TO: City of Gainesville
 Development Review Board

DATE: November 22, 2016

SUBJECT: Petition DB-16-110 SUB. EDA, Inc. (Sergio Reyes), agent for Freddie and Dinah Stone, owners. Design plat review for a residential subdivision of Tax Parcels: 06165-000-000 and 06166-000-000 to create eighteen single-family residential lots. Zoned: RSF-4 (8 units/acre single-family residential district). Located at 4811 NW 27th Avenue.

Sheet No.: C0.00

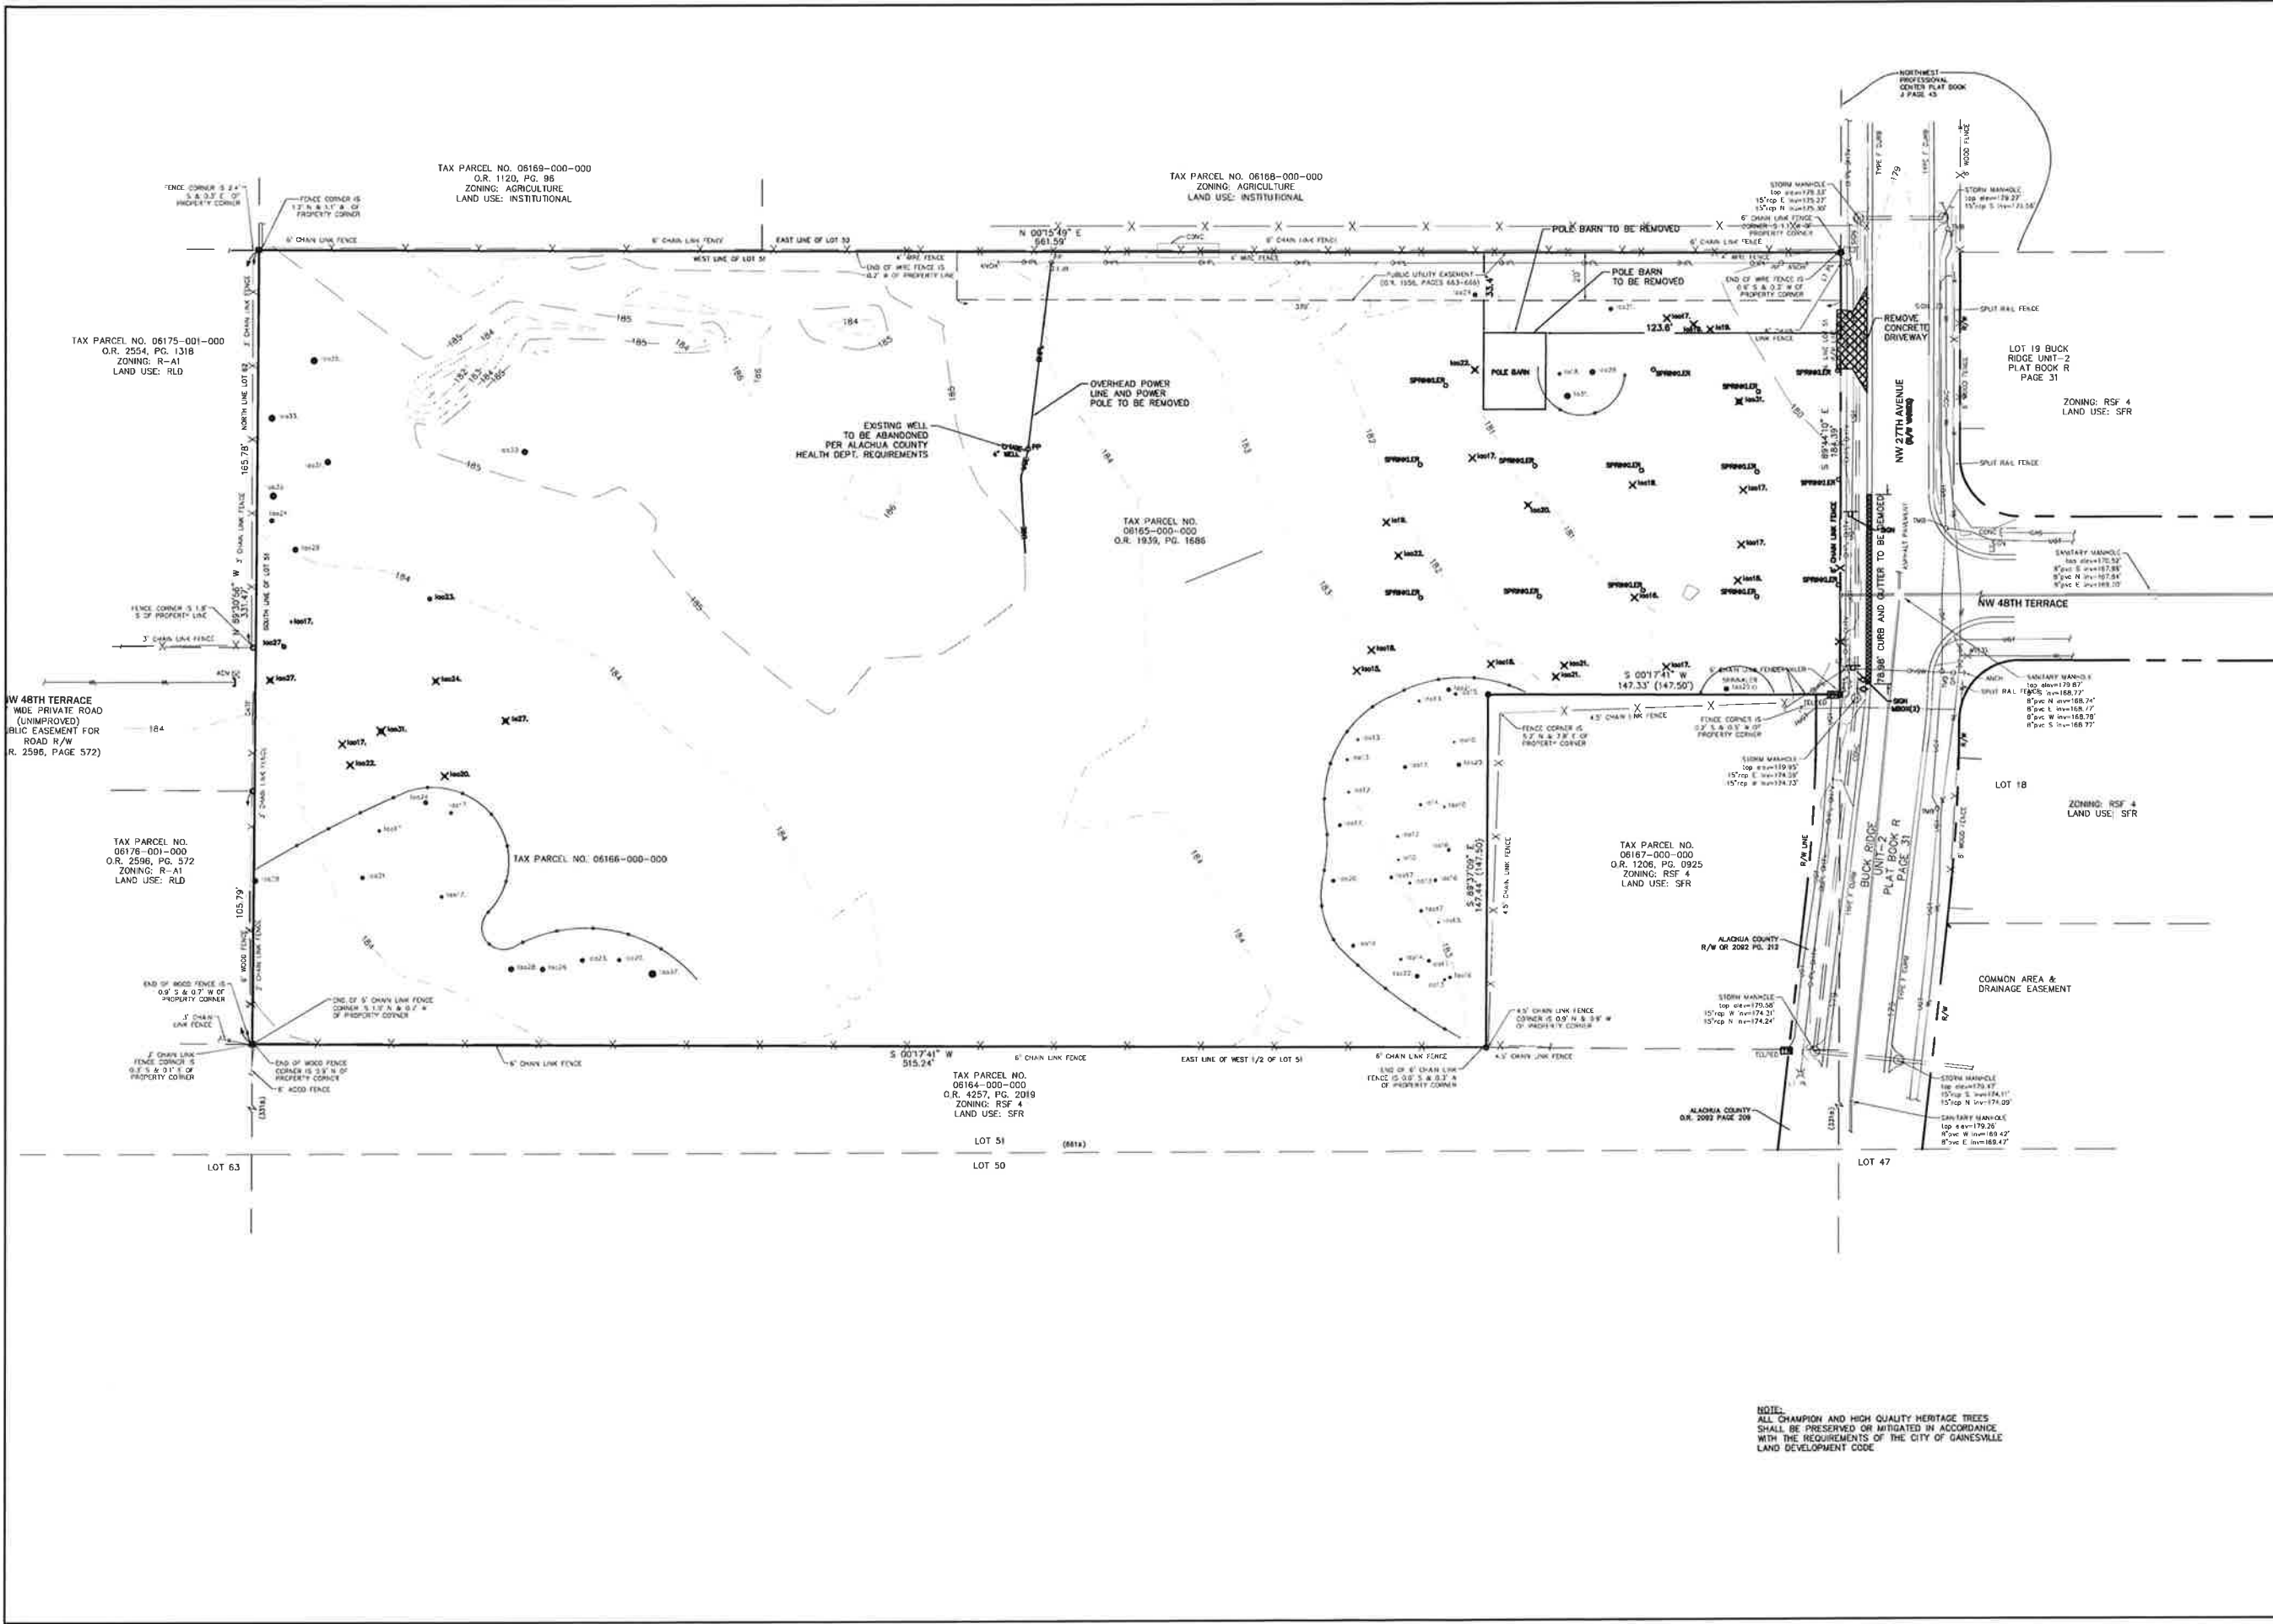
1. Note #13 on sheet C0.00 say's, "Mobility Transportation Program Area (TMPA), when it should say, "Transportation Mobility Program Area (TMPA)." Please correct.
2. Prior to receiving a final development order, this development must sign a TMPA Zone B Agreement for the provision of 3 Transportation Mobility element Policy 10.1.6 criteria.

1. Please amend note #13 on sheet C0.00 to say that, "This site is located in Zone B of the Transportation Mobility Program Area (TMPA) and will comply with the applicable provisions of Transportation Mobility Element Policies 10.1.4. and 10.1.6"

Response: Sheet C0.00 has been revised accordingly.

Response: The trip generation tables have been revised to reflect the percent change between Saturday and weekday peak, which indicates that weekly ADT is 28.8% less than Saturday ADT. See C0.00.

Response: The tables have been revised to address this comment. The appropriate ratio of 0.45 for peak hour of adjacent traffic is used. See C0.00.

Response: A TMPA payment will be made to meet this requirement, see note on sheet C0.00.

Response: Sheet C0.00 has been revised as requested.

Response: Sheet C0.00 has been revised as requested.

Response: Sheet C0.00 has been revised as requested.

Sheet No. **C1.00**

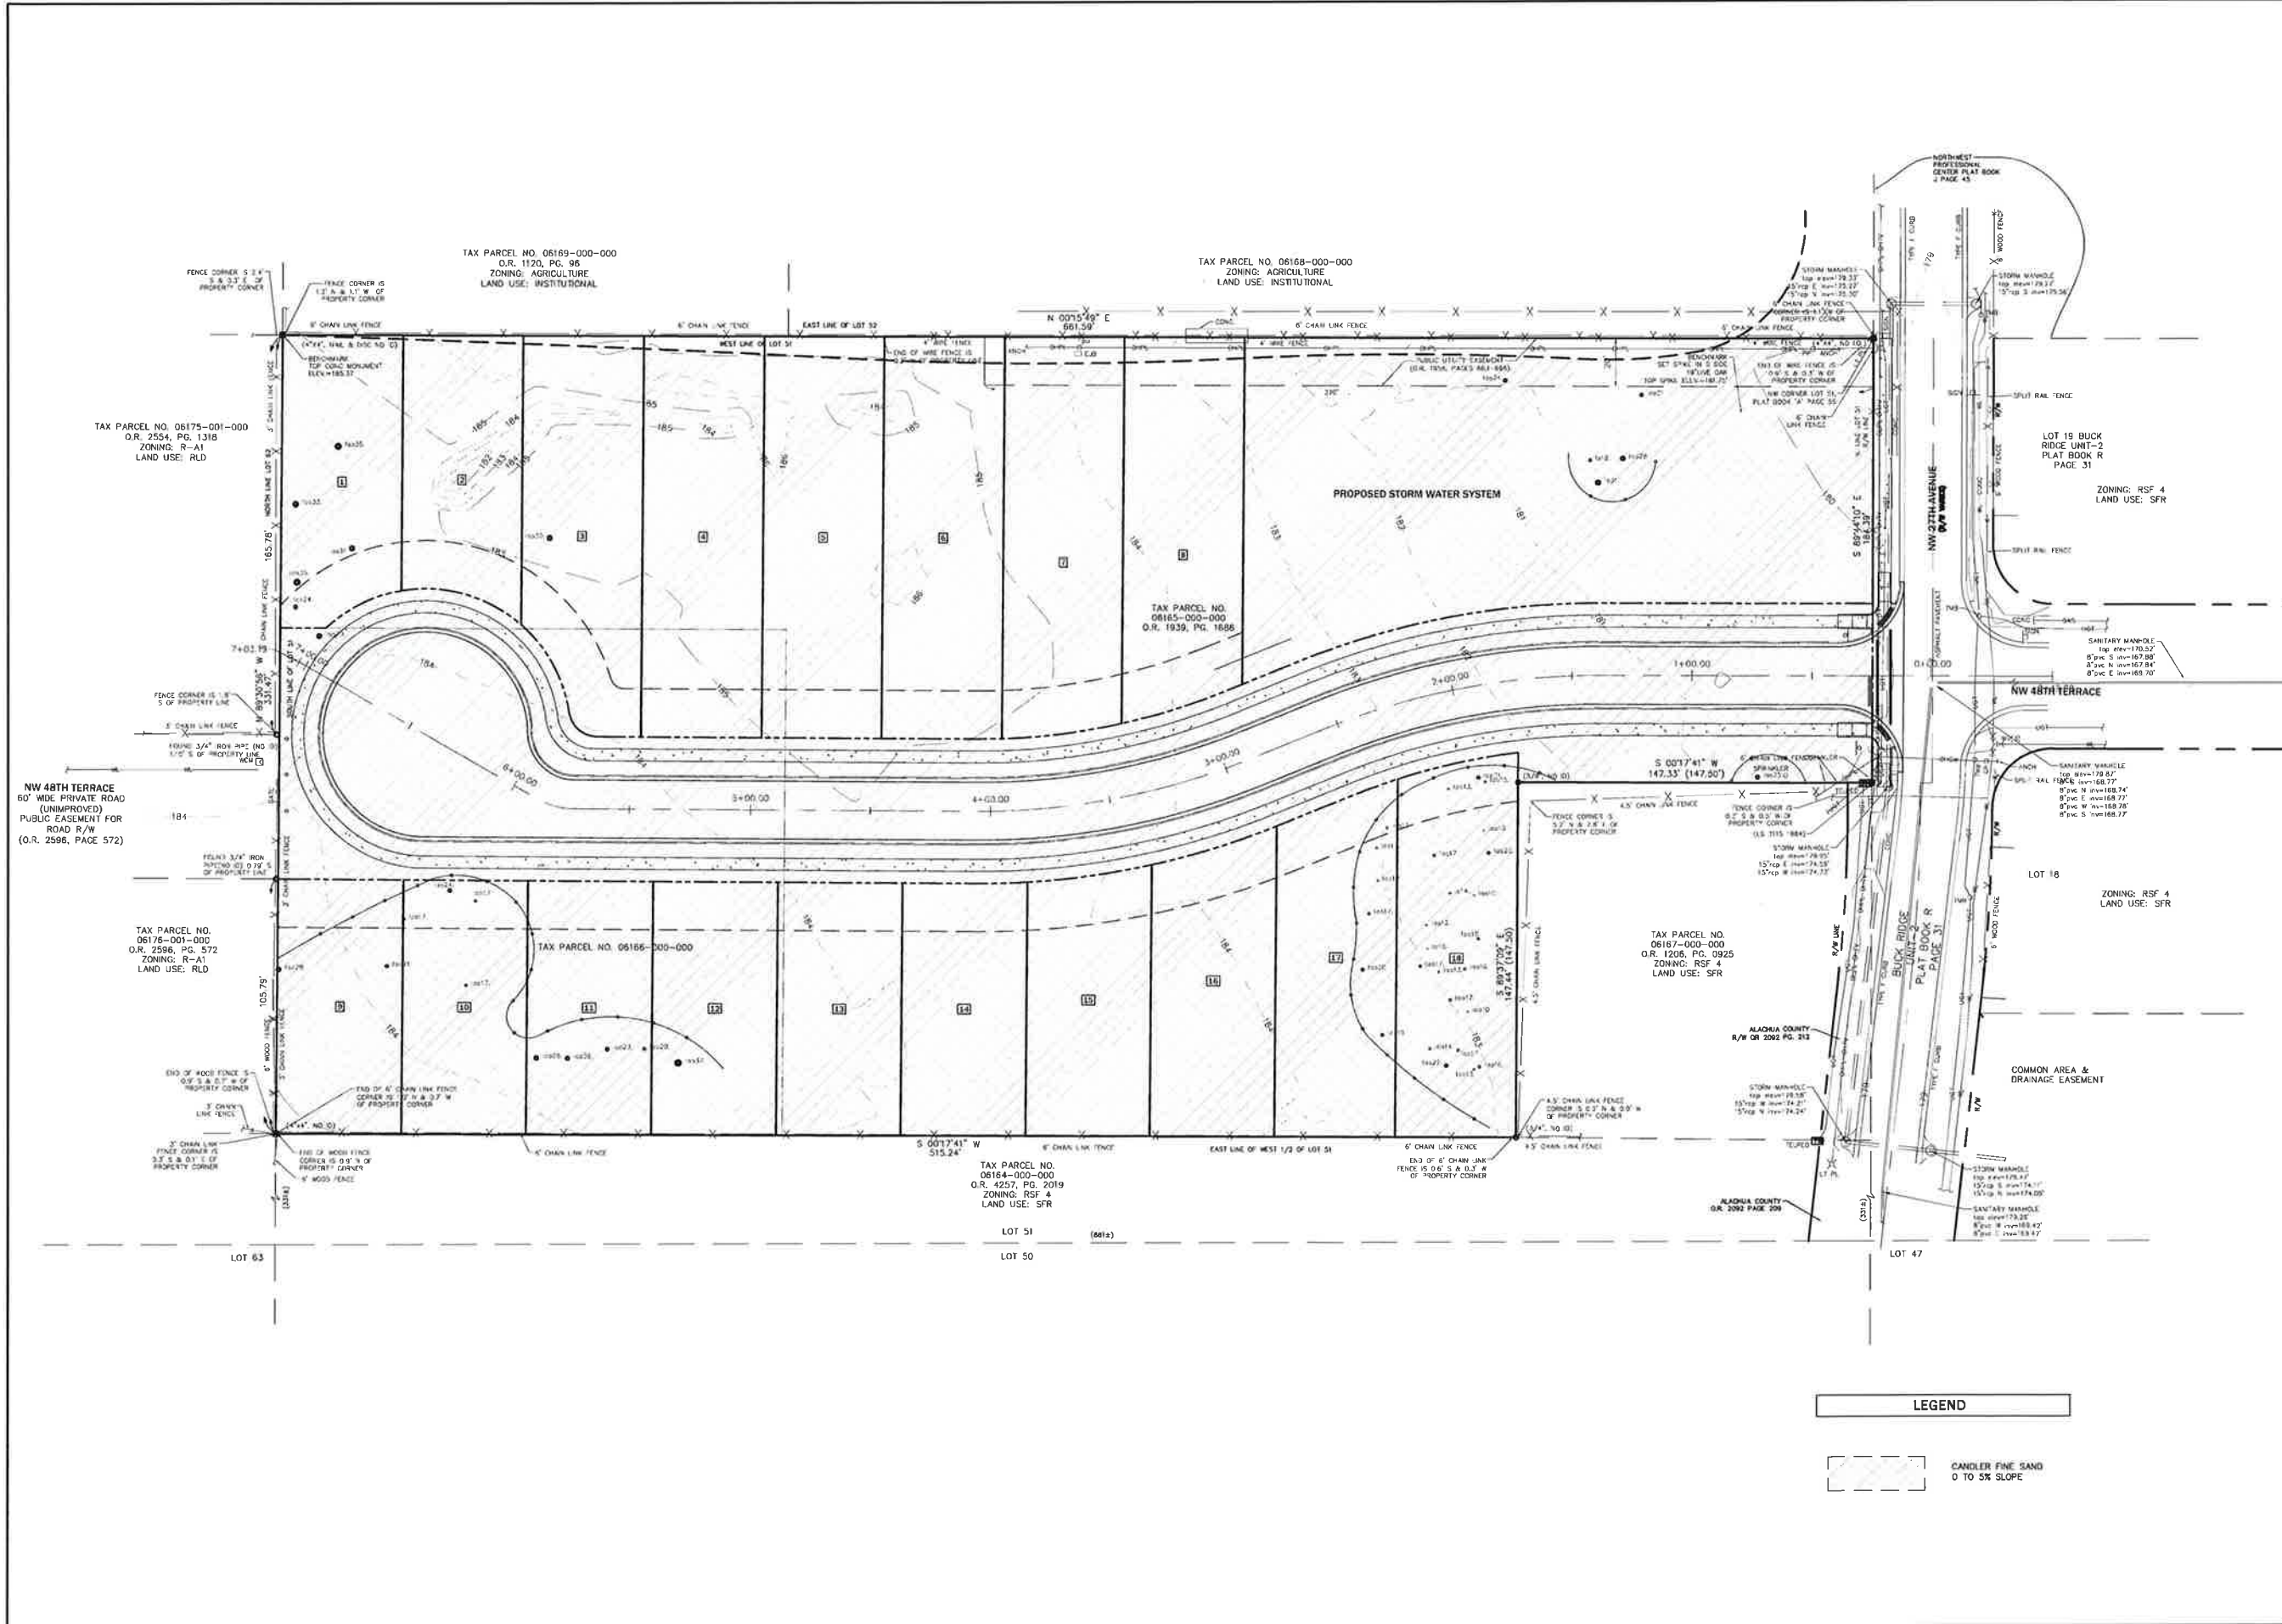
4. Please show the vehicular and sidewalk stub-outs for proposed and future connections. The vehicular stub-out can be blocked to allow only emergency vehicular access.

Response: A cul-de-sac is proposed on the revised plans, see sheet C1.00.

Response: Crosswalk has been provided. See sheet C1.00.

Response: A cul-de-sac is proposed on the revised plans, see sheet C1.00.
